Norfolk Vanguard Offshore Wind Farm Development Consent Order (the Project)
Case reference no: EN010079
The Applicant: Norfolk Vanguard Limited

Request to submit information into the Examination: Application Documents Errata, and Change Report.

Norfolk Vanguard Offshore Wind Farm Change Report

Applicant: Norfolk Vanguard Limited
Document Reference: Pre-ExA; Change Report; 9.3

Figure: 5	Drawing No: PB4476-008-000-005				
Revision:	Date:	Drawn:	Checked:	Size:	Scale:
03	28/11/2018	LB	JA	A3	1:2,500
02	08/10/2018	LB	JA	A3	1:2,500

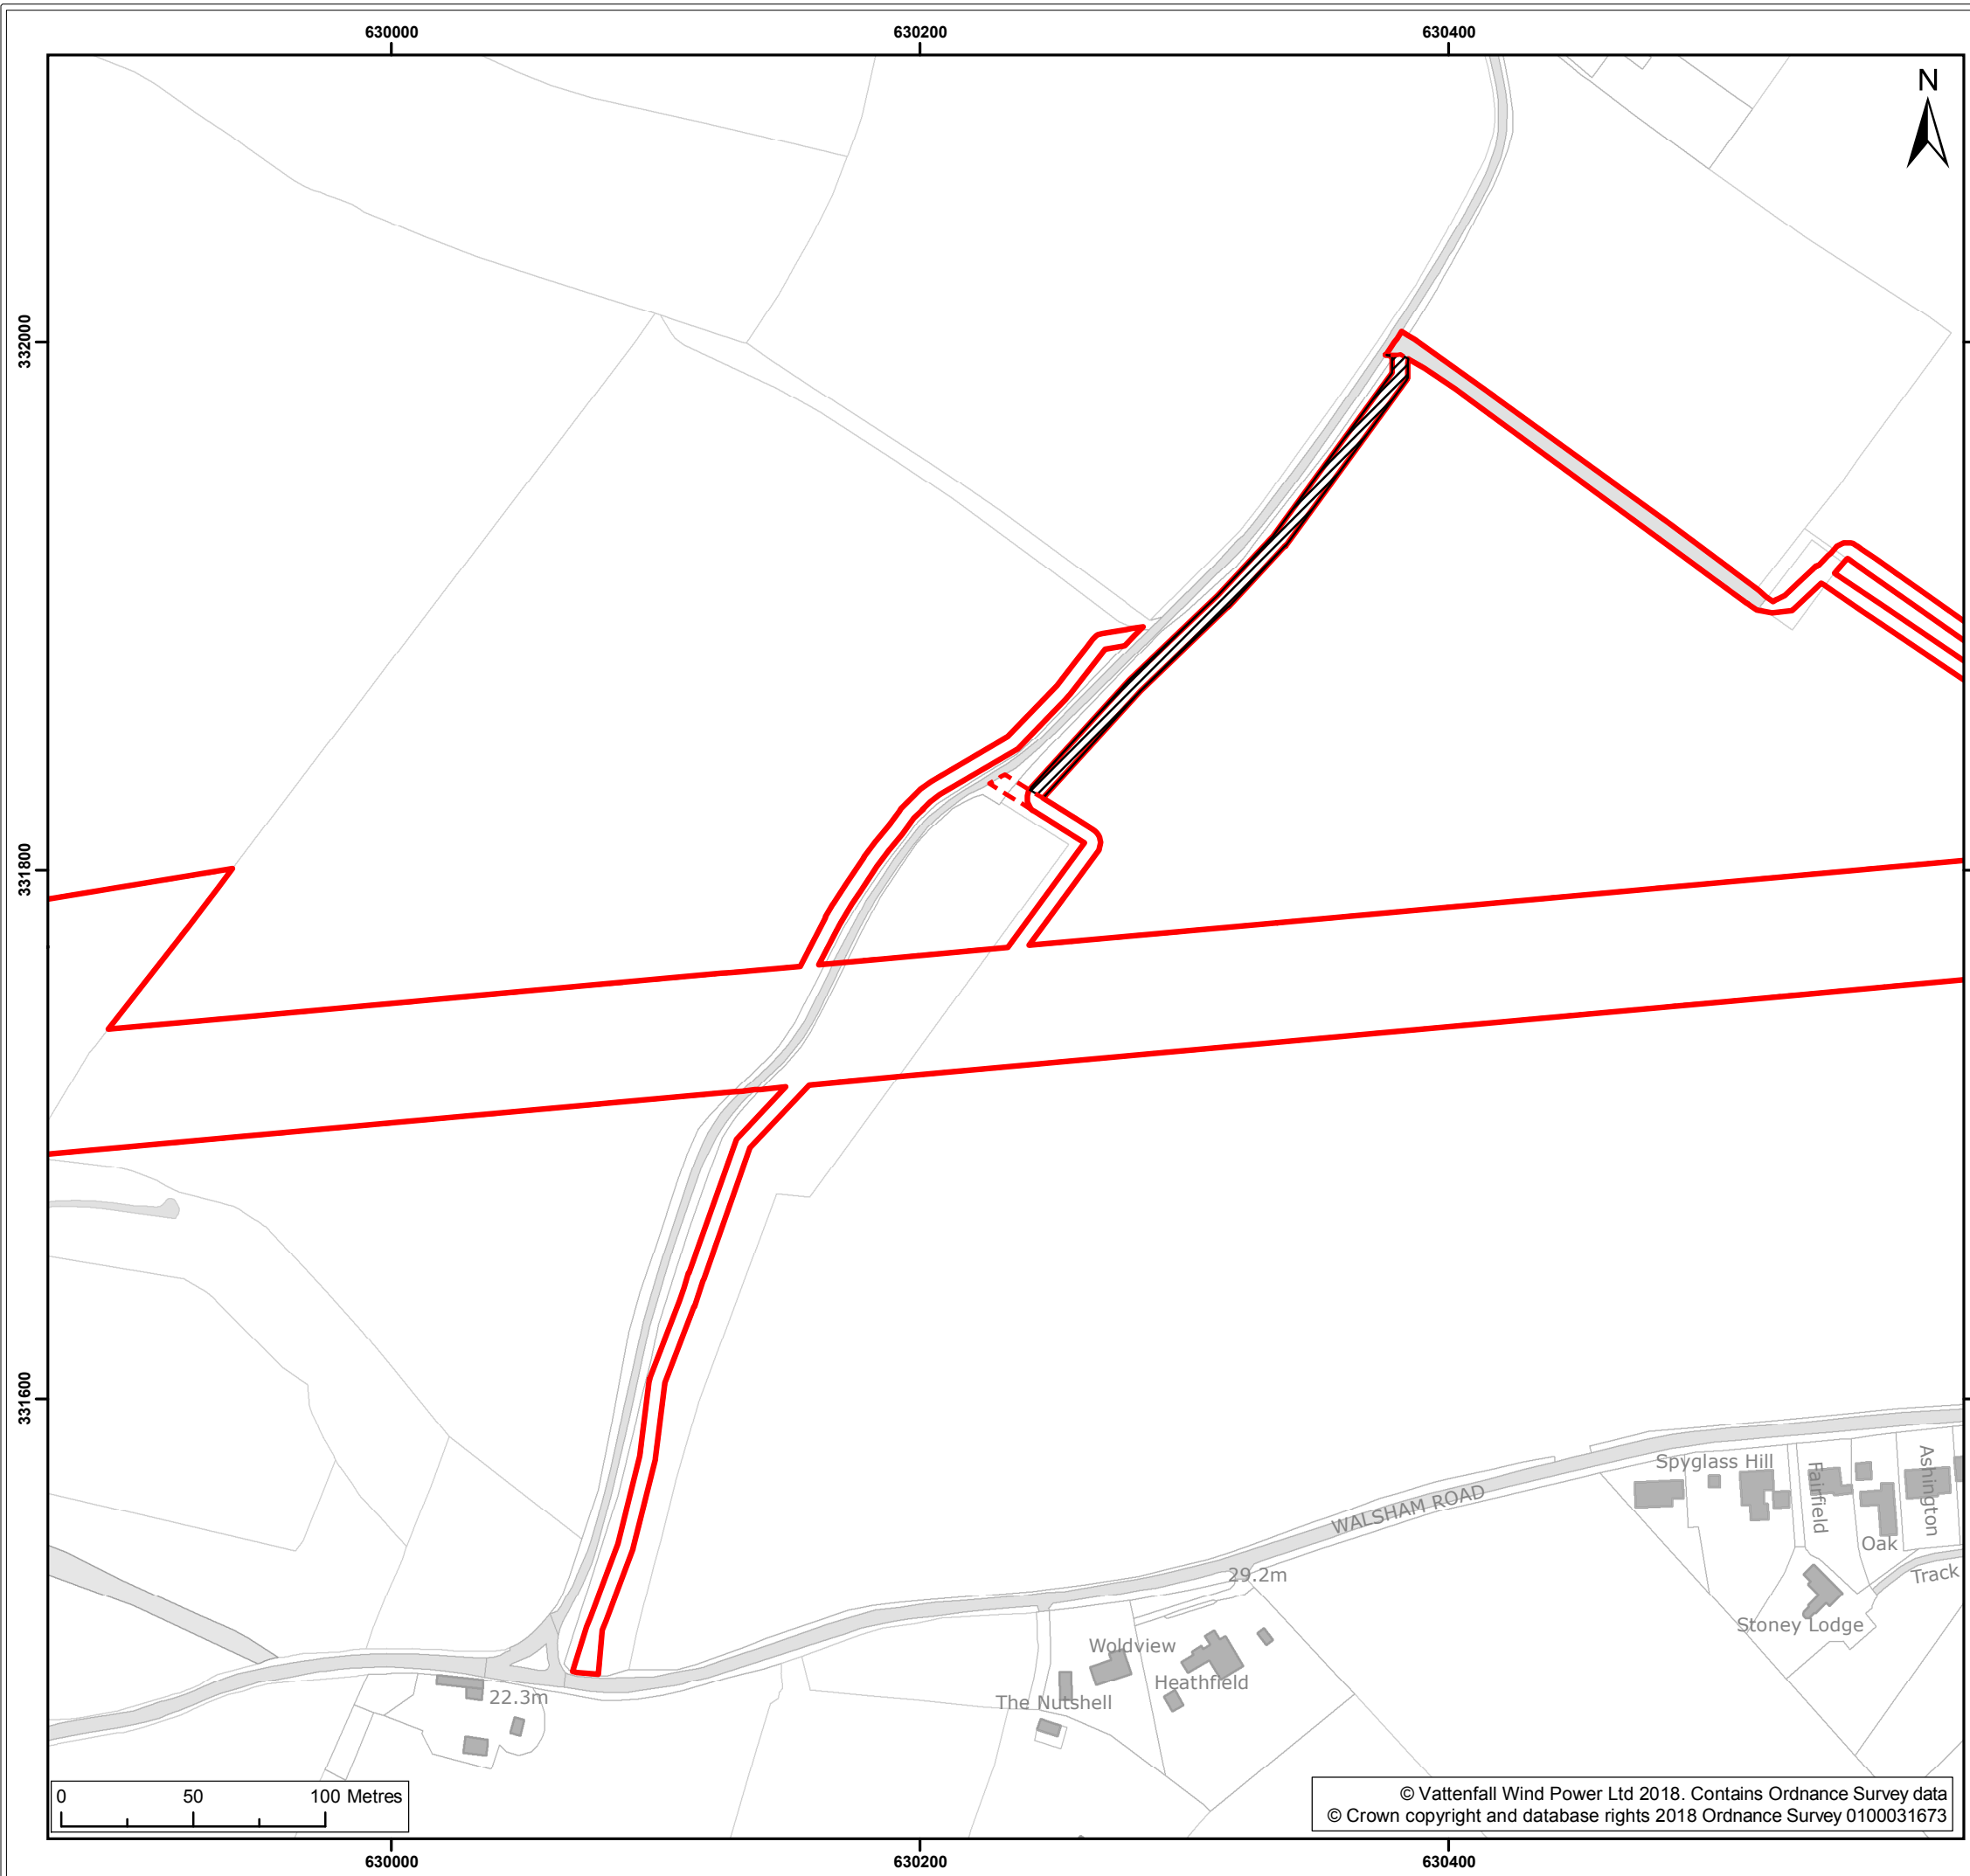
2.2.5 Access amendment – S Hammond (Plot No. 07/05 – Land Plans Sheet 7)

81. The location of this amendment is centred on National Grid Reference TG 302 318. The proposed change to this operational access is shown on Figure 5, which also indicates the extent of the Order limits within the original application that are no longer required.

Figure: 6	Drawing No: PB4476-008-002-006				
Revision:	Date:	Drawn:	Checked:	Size:	Scale:
04	12/12/2018	GC	JA	A3	1:10,000
03	28/11/2018	LB	JA	A3	1:5,000

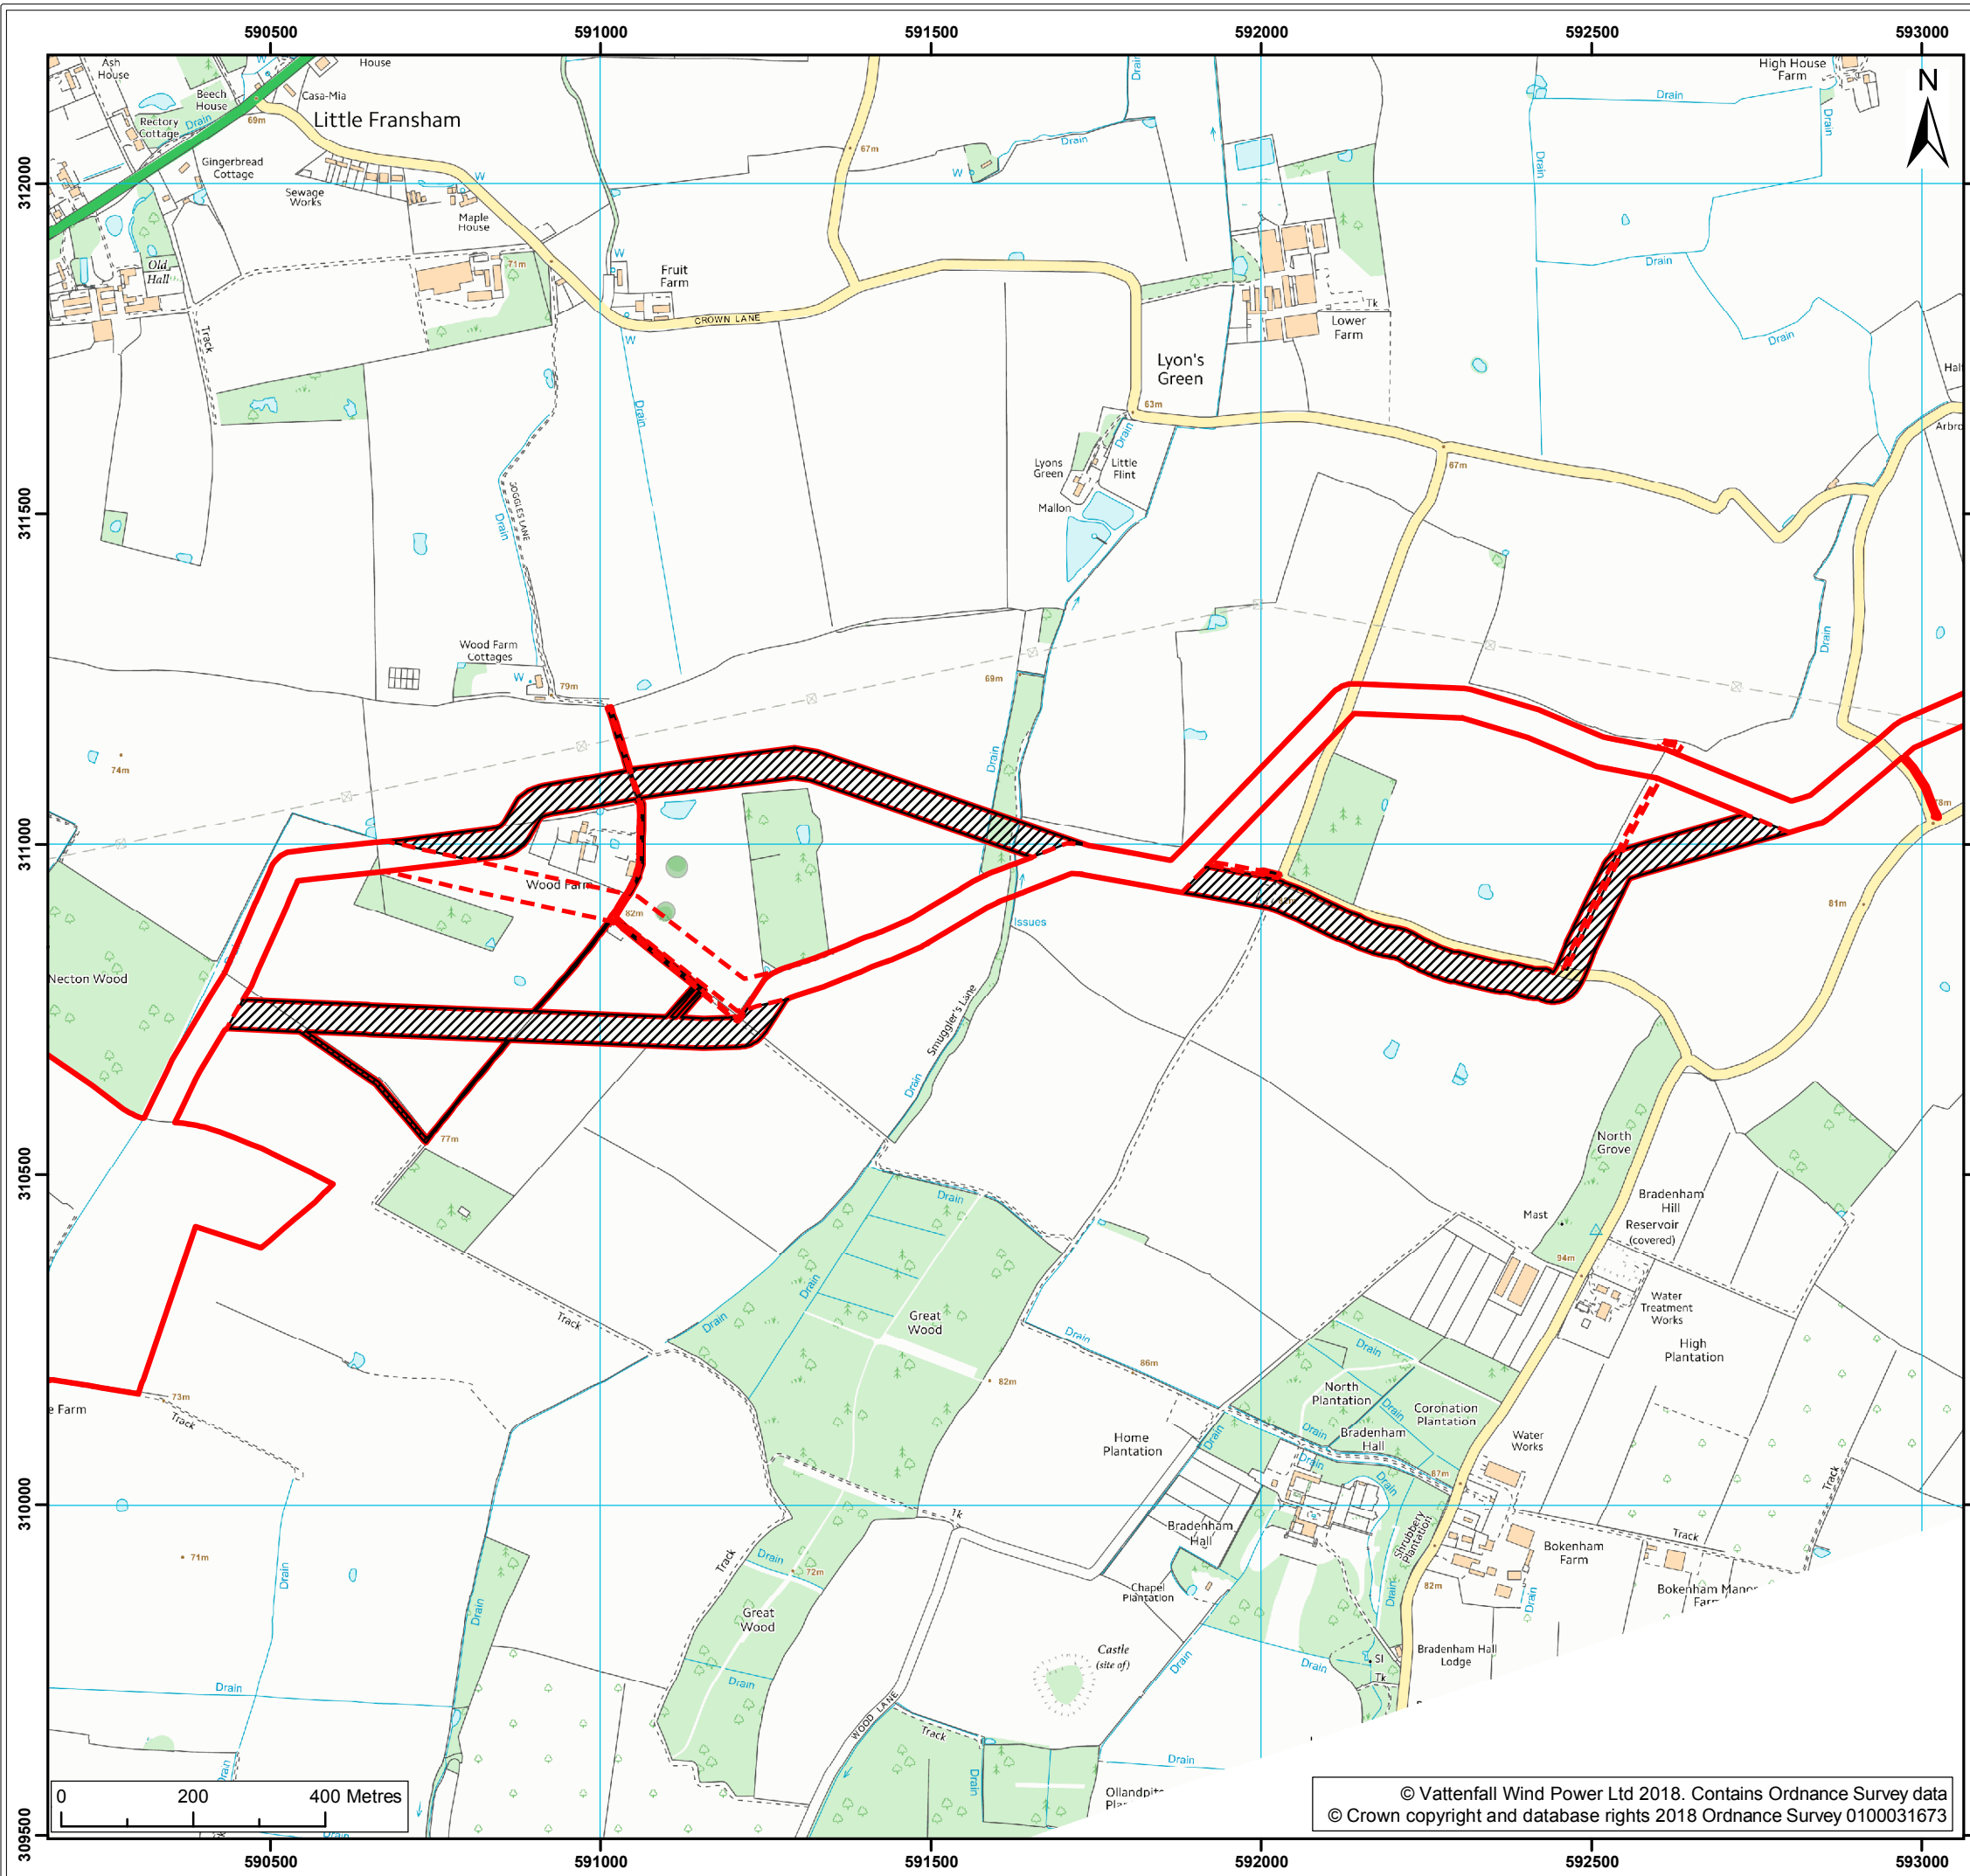
2.2.6 Route amendment – C Allhusen (Plot No. 38/10, 39/4, 39/5, 39/06, 39/07, 39/08, 39/11, 39/13, 39/14, 39/15, 40/01, 40/03, 40/04, 40/05, 40/06, 40/07, 40/10, and 40/12 – Land Plans Sheet 38, 39 and 40)

86. The proposed route amendment is shown on Figure 6, which also indicates the extent of the Order limits within the original application that are no longer required. The total length of the preferred route is the same as the previously assessed northern route in this location (both 2.7km in total). The route amendment is wholly located within the same two arable fields as the originally assessed alignments, and located wholly within the EIA study areas identified within the submitted Environmental Statement.
87. Table 2.14 provides a consideration of the proposed route amendment in relation to each of the previously assessed onshore EIA topics.
